City of Richmond
Planning and Development Department

Request for General Compliance

To: Development Permit Panel
From: Brian J. Jackson, MCIP
Director of Development
Date: August 12, 2010
File: DP 04-269797
Re: **Application by HBBH + CE Integratedesign BC Inc. for a General Compliance at 14000, 14088, 14100, 14200 and 14300 Riverport Way (formerly 14791 Steveston Highway)**

Plan 1A Aug 10 2010
DP 04-269797

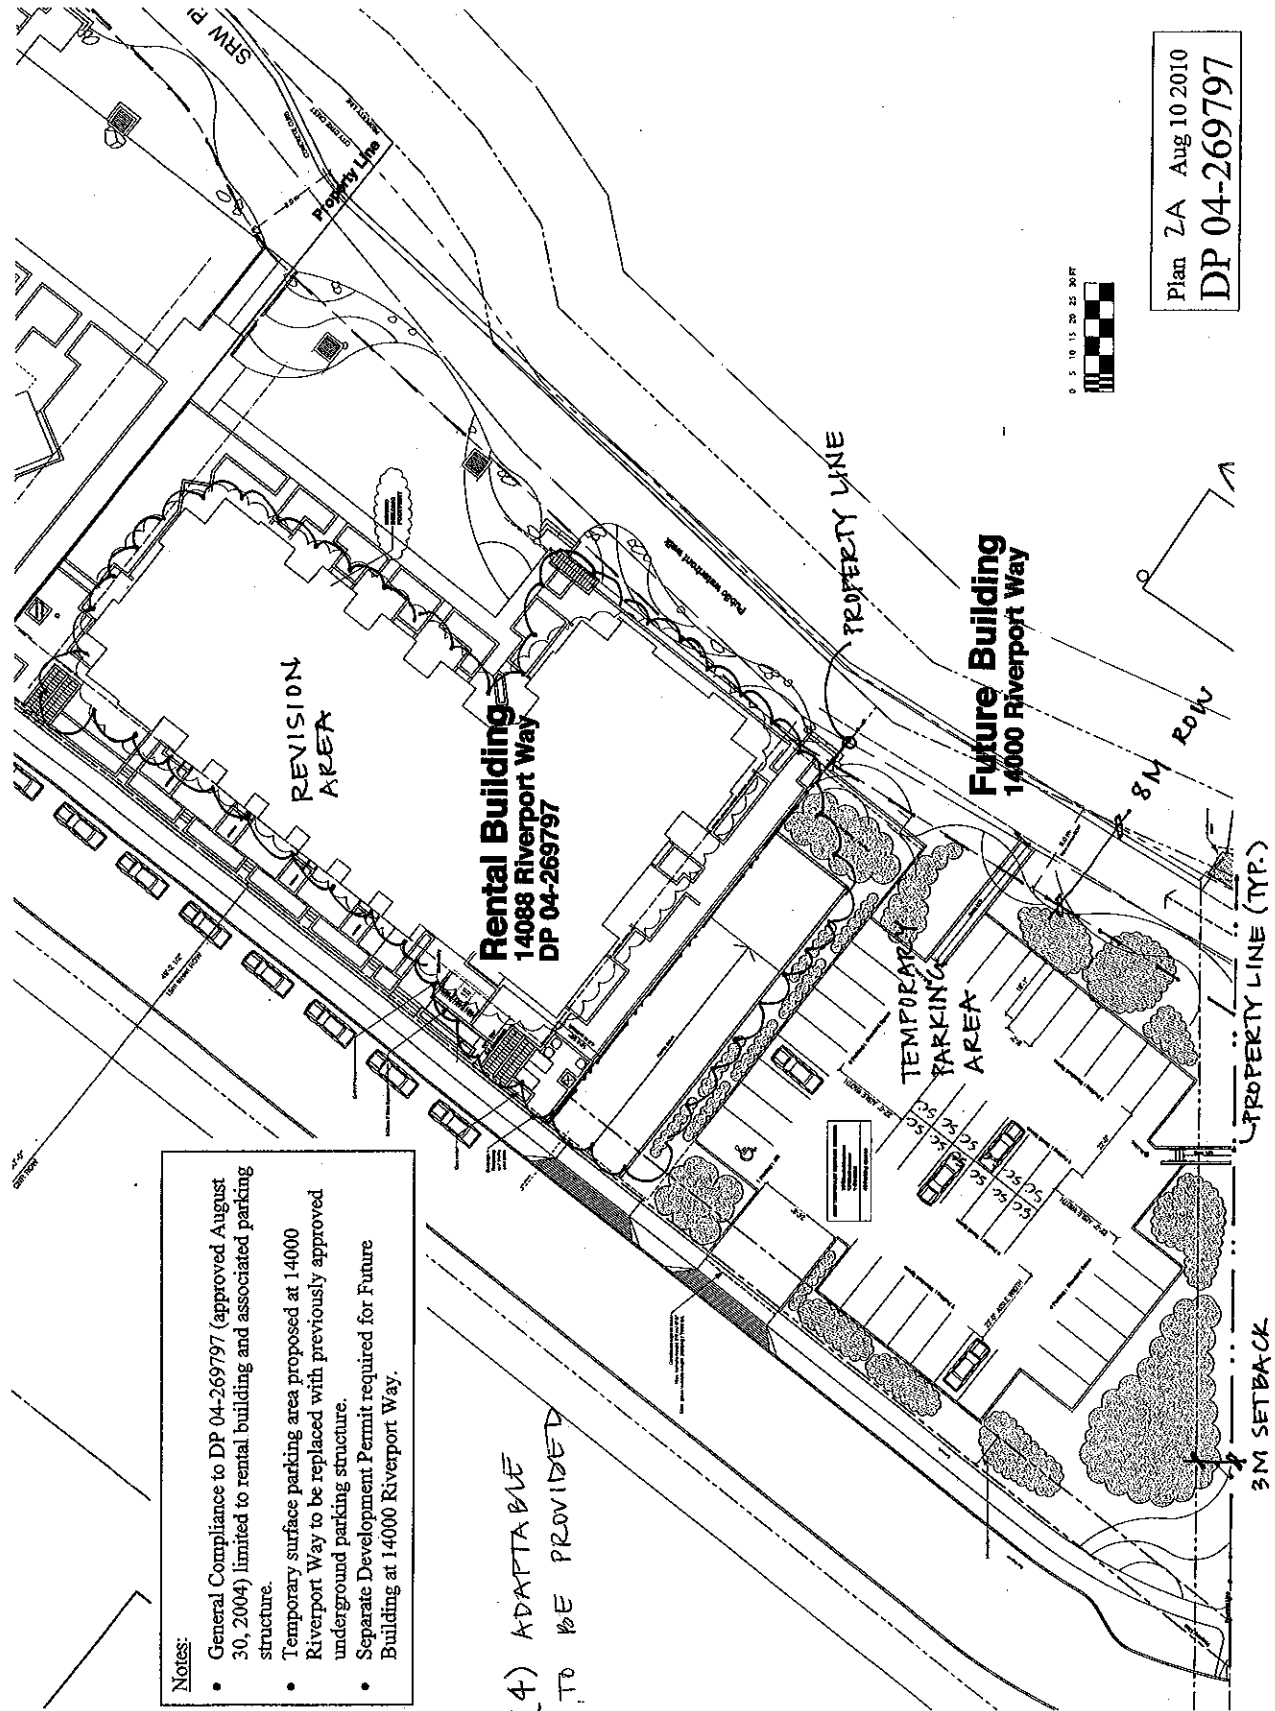
A revised building design is proposed to increase the number of rental apartment dwelling units from 67 to 80. The increased number of apartments are proposed to address a change in market conditions and accommodate an increased need for rental accommodation. This has resulted in revisions to the floor plan layouts, building footprint, and elevations.

The proposed parking layout under the rental building accommodates an increased 80 parking spaces and 100 secured Class 1 bicycle storage spaces. The remaining required 43 parking spaces will be provided as temporary surface parking on the adjacent lot at 14000 Riverport Way until the original approved southern portion of the underground parking structure is constructed, or a subsequent future Development Permit covering this area is approved.

- General Compliance to DP 04-269797 (approved August 30, 2004) limited to rental building and associated parking structure.
- Temporary surface parking area proposed at 14000 Riverport Way to be replaced with previously approved underground parking structure.
- Separate Development Permit required for Future Building at 14000 Riverport Way.

Plan 3A Aug 10 2010
 DP 04-269797

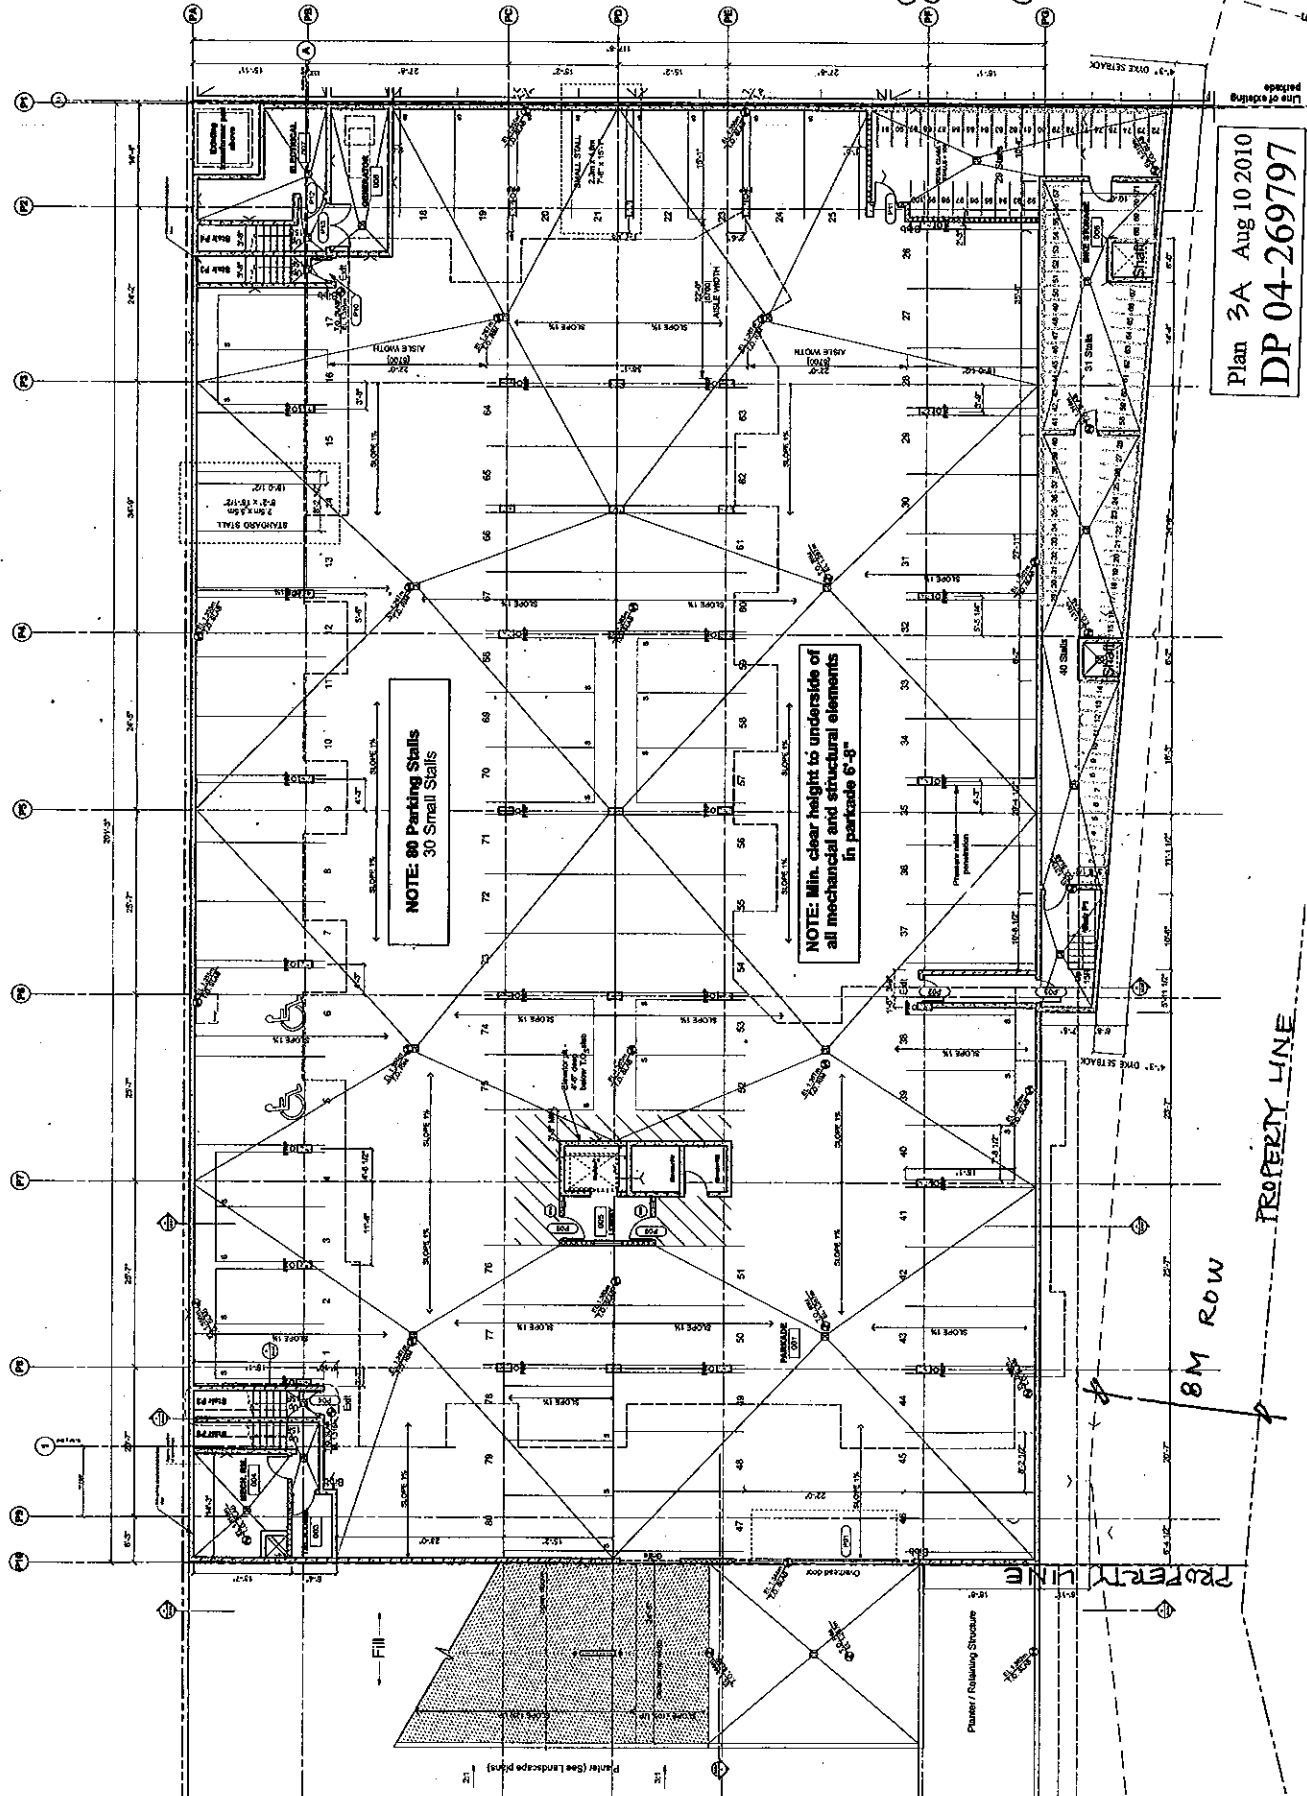
The approved design included a parking structure under all areas of the overall original site, with a second lower level under the rental building (14088 Riverport Way). The lower level of underground parking is proposed to be deleted as it is not feasible due to on-site upward water pressure geotechnical constraints.

The access ramp to the parking structure was relocated southward, providing a separation from the rental building to improve liveability for the southwest facing units.

**NOTE: 80 Parking Stalls
 30 Small Stalls**

Plan 4-D Aug 10 2010
 DP 04-269797

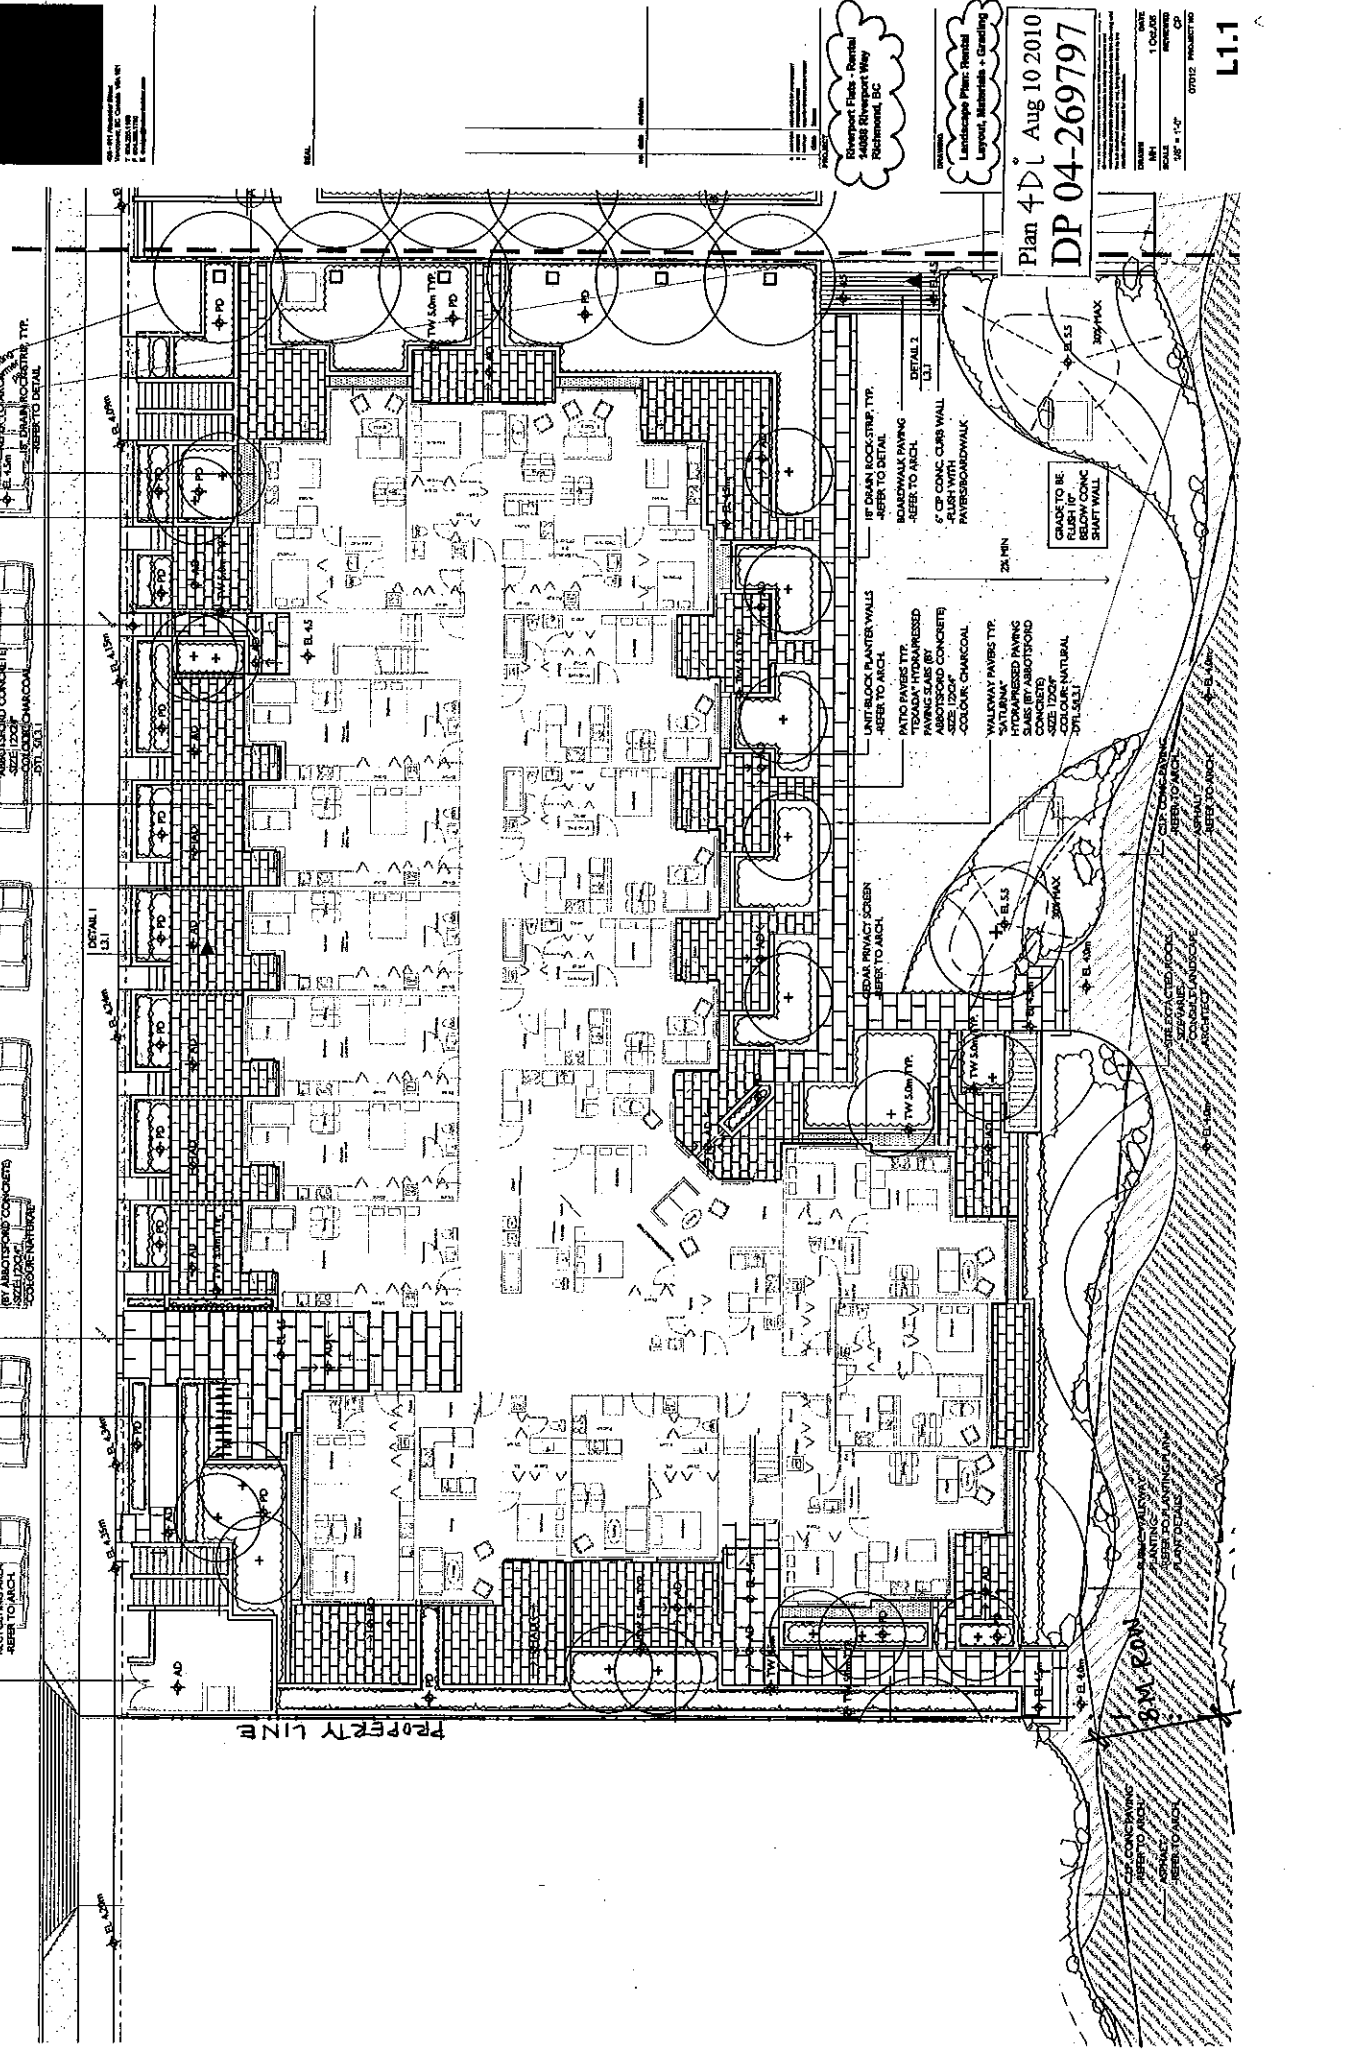
The landscape design remains unchanged, with the exception of localized changes surrounding the rental building to accommodate the revisions to the building and parking structure.

The temporary surface parking area will be screened from the adjacent streetscape and public walkway with landscape treatment at the edges.

3.0 Elevations

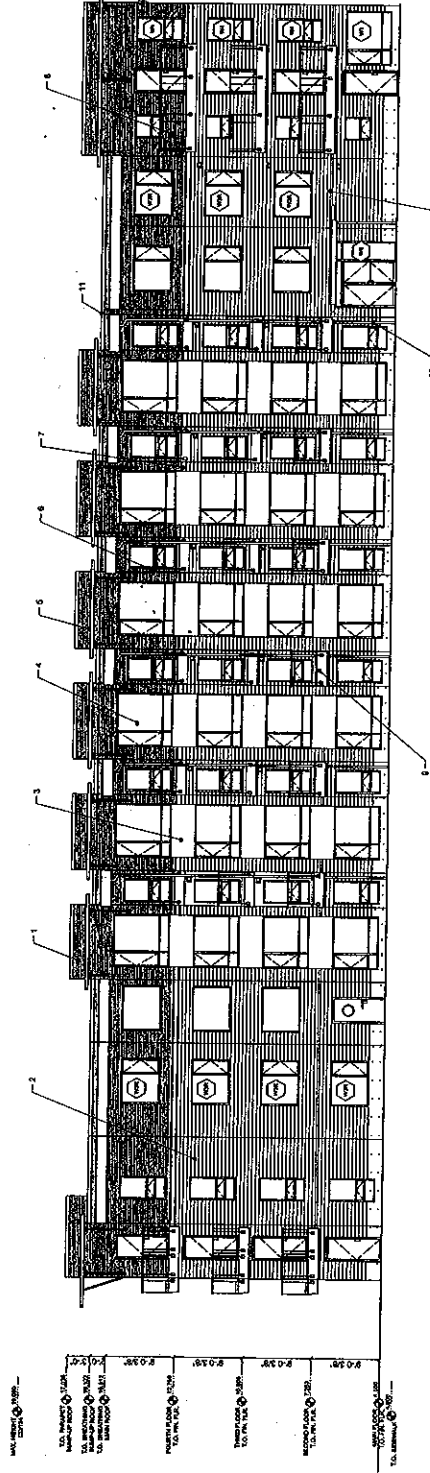
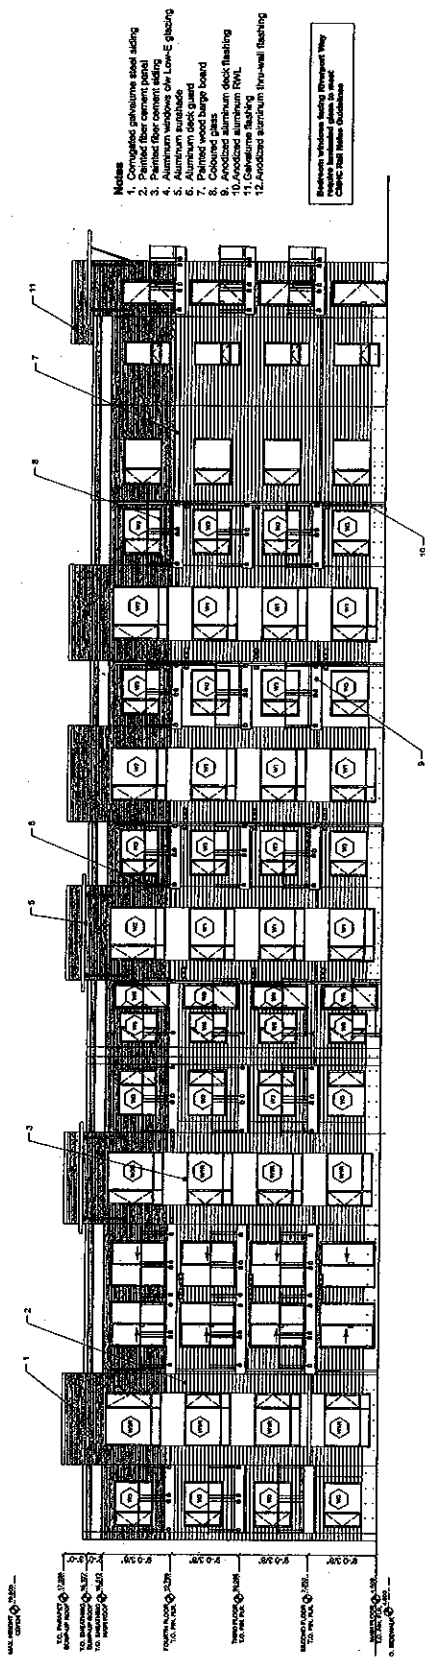
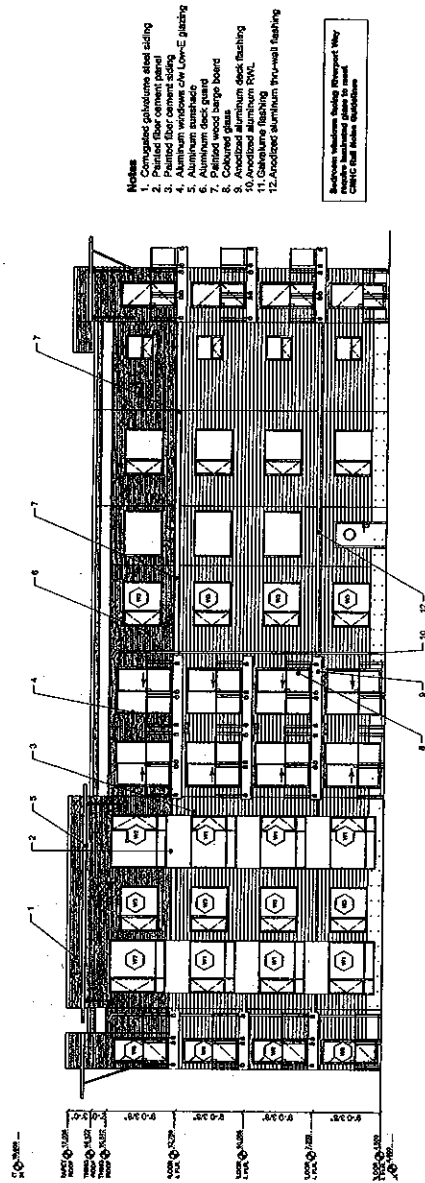
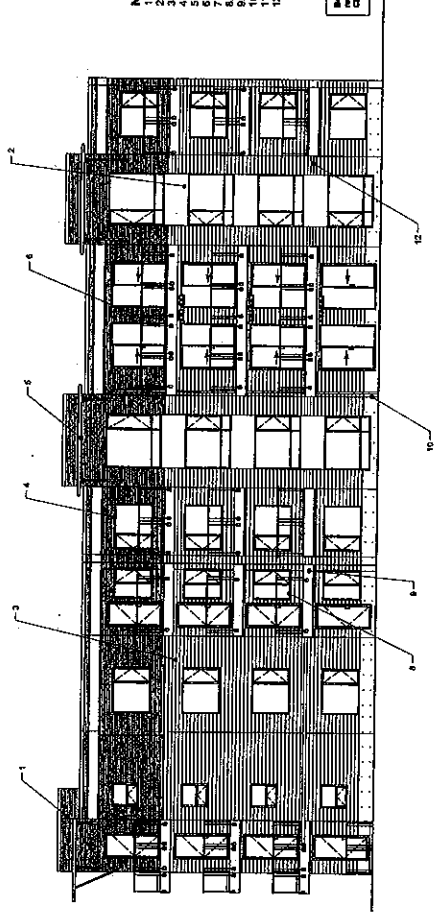
The proposed building footprint and elevations include shifted and additional projecting building bays to accommodate a larger number of balconies and building articulation in a manner that is consistent with the overall architectural form and character approach of the approved design.
